RE: New York SMSA Limited Partnership d/b/a Verizon Wireless Special Permit and Site Plan Application to Install a Public Utility Personal Wireless Facility at the Property Known as 52 Montrose Station Road, Town of Cortlandt, NY

Specifically, the redesigned Facility and the documents submitted herewith respond to the comments raised by the Town Engineer and Town RF Consultant as follows:

Response to the Comments from Town Engineer:

SBL# 44.07-1-4
 N/F Conklin, Frank & Elizabeth
 Deed No. 493503018
 52 Montrose Station Rd
 6.00± AC (per Assessor)

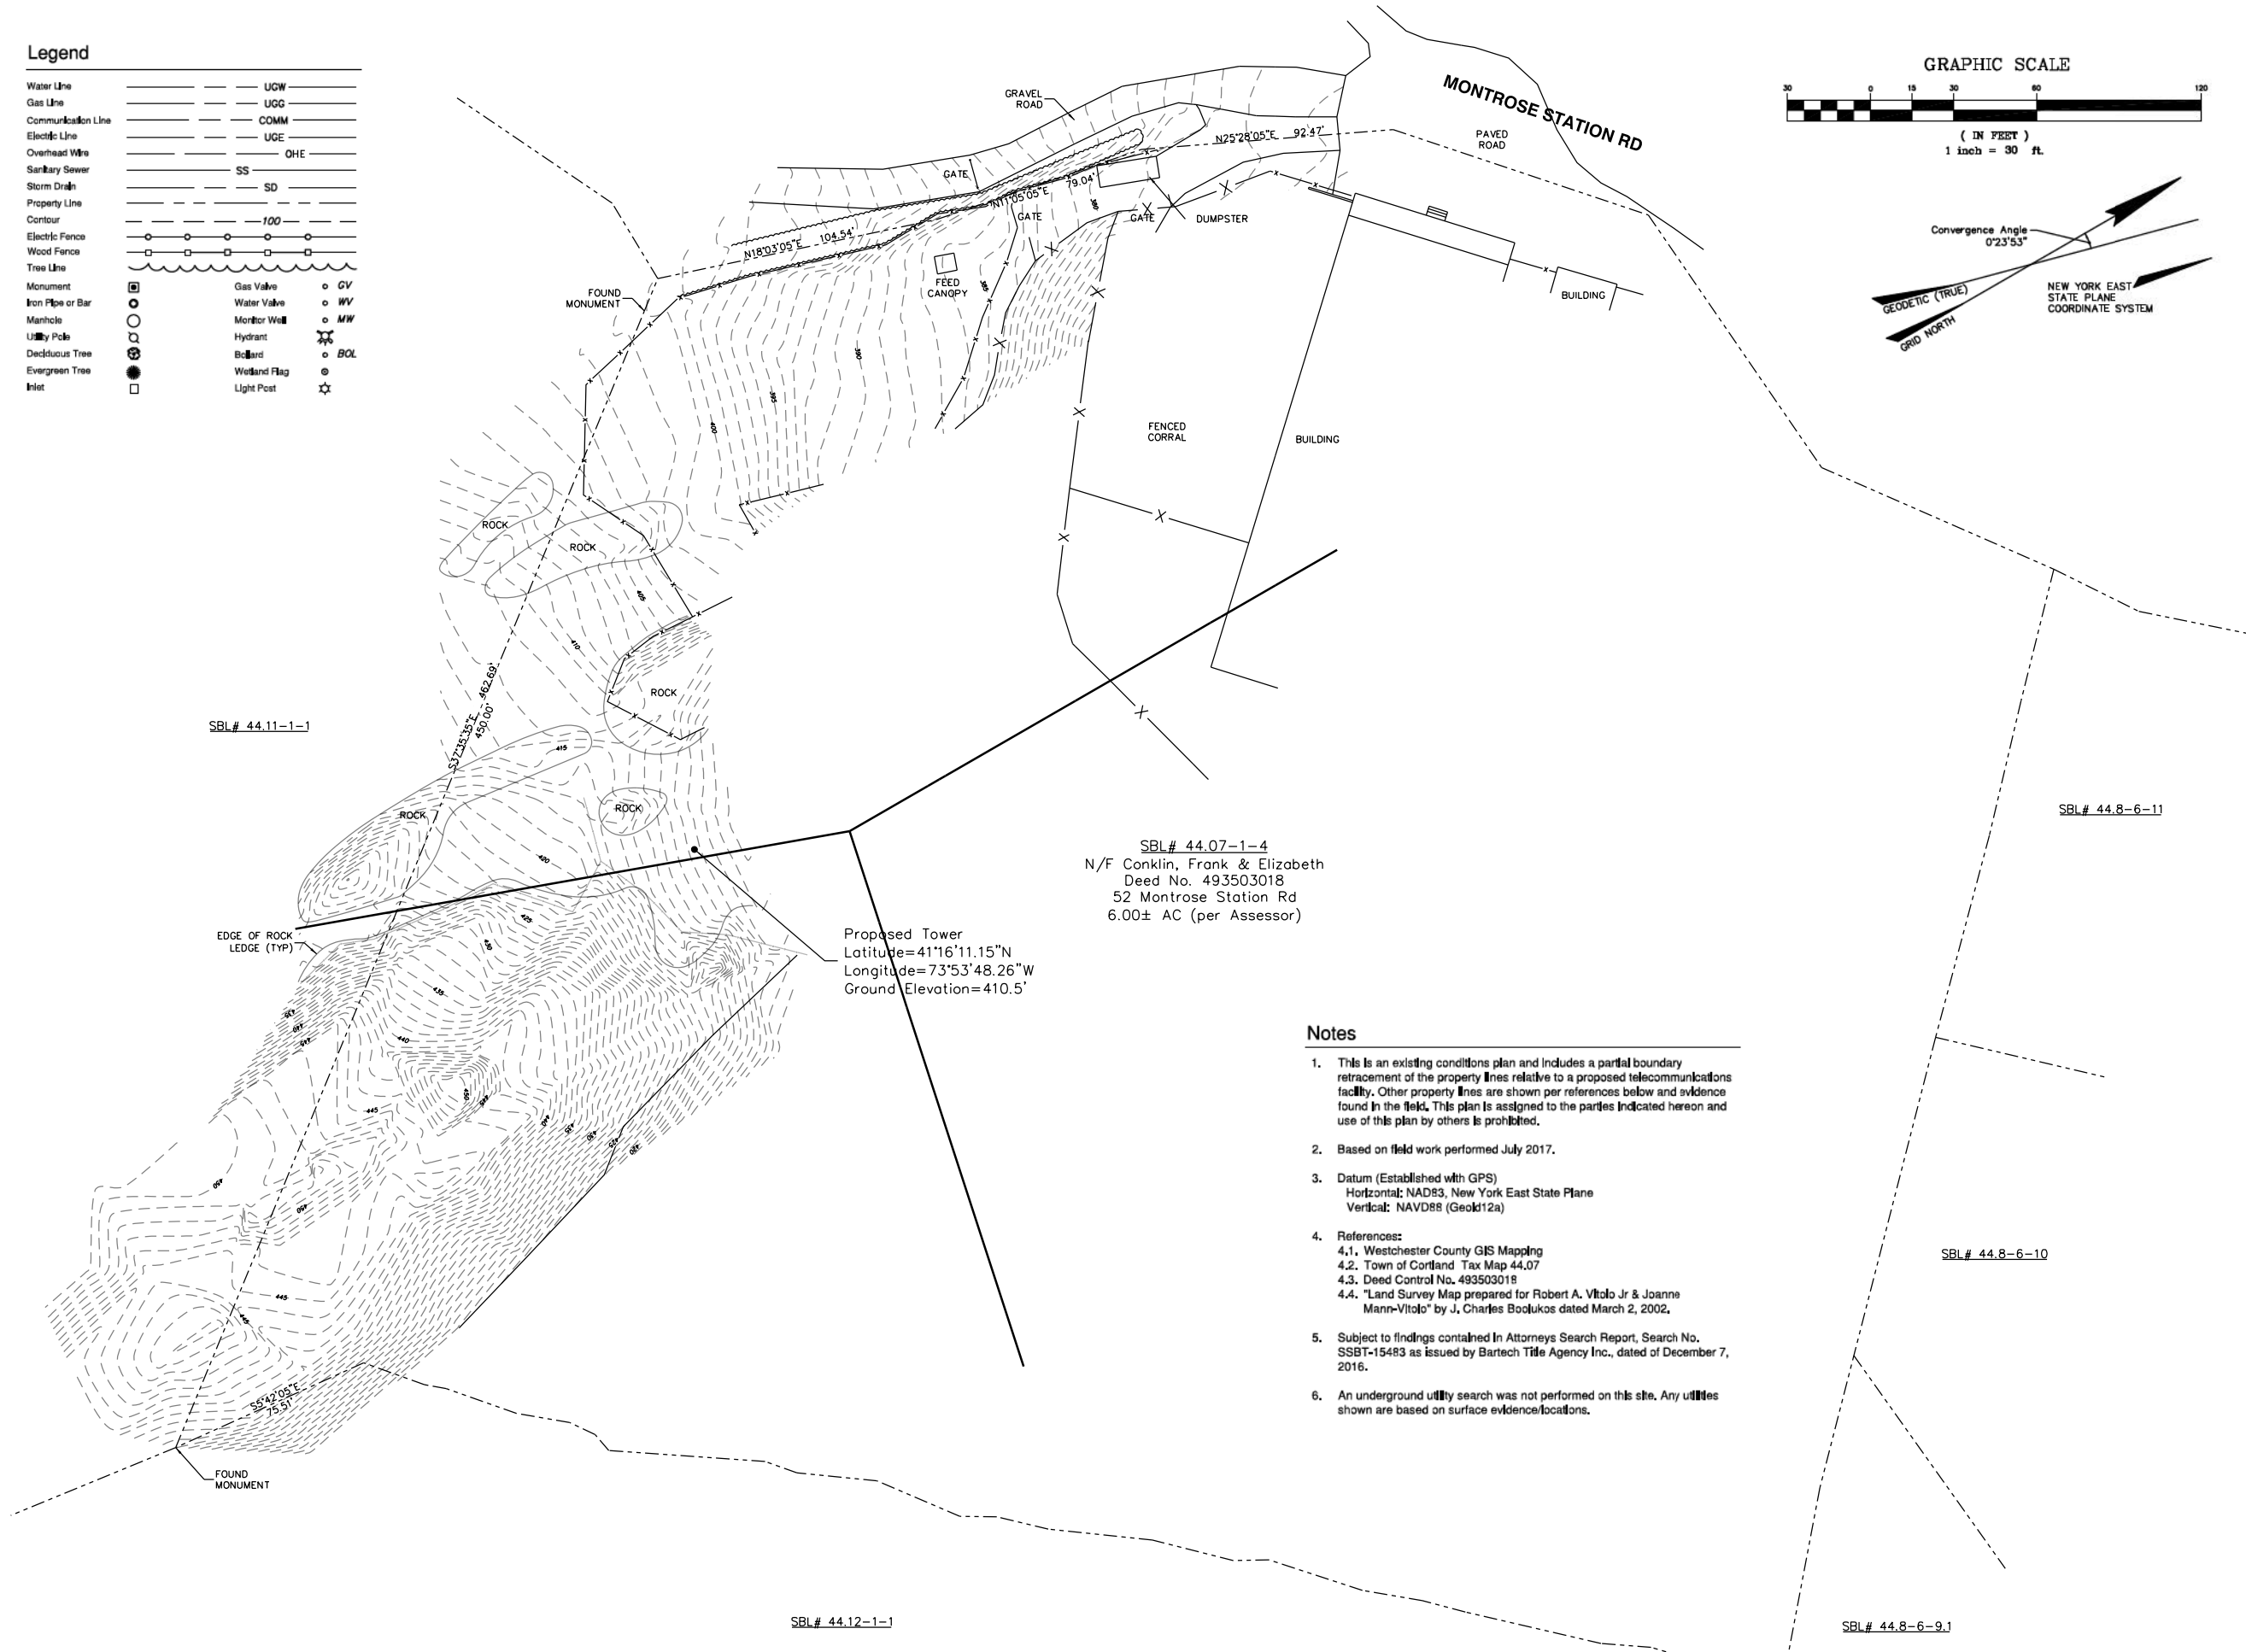
- *Extensive re-grading is proposed. Field based topography within 100-ft of the proposed limits of disturbance shall be provided. In addition the Applicant must provide a topographic and geomorphologic study within the disturbance limits. The Applicant shall complete a Steep Slope analysis in accordance with Town Code Chapter 259.*

Applicant has not indicated the source of topography shown on the plans. Topography shall be field surveyed by a licensed professional land surveyor in contour intervals not to exceed 2-ft. Existing and proposed grading shall be shown

Response: Sheet Z-10 of the Revised Plans is an existing conditions survey, which was incorporated on to the Detailed Site Plans on Sheet Z4 of the Revised Plans. Additionally, as indicated on the Updated EAF attached hereto as Exhibit 2, 100% of the proposed work will take place in areas with slopes of 0-10%. Accordingly, a steep slope permit is not required as such slopes are below 15%, which constitutes a steep slope according to Section 259-3 of the Town Code. Additionally, it is respectfully requested that the topographic and geomorphological study within the disturbance limits be a condition of the building permit, after the location of the Facility has been approved.

- Proper Building Code references. 2015 IFC and 2017 NYS Uniform Code supplement. -- See Sheet Z-1 of the Revised Plans
- Reference to property survey. -- See Sheet Z-10 of the Revised Plans
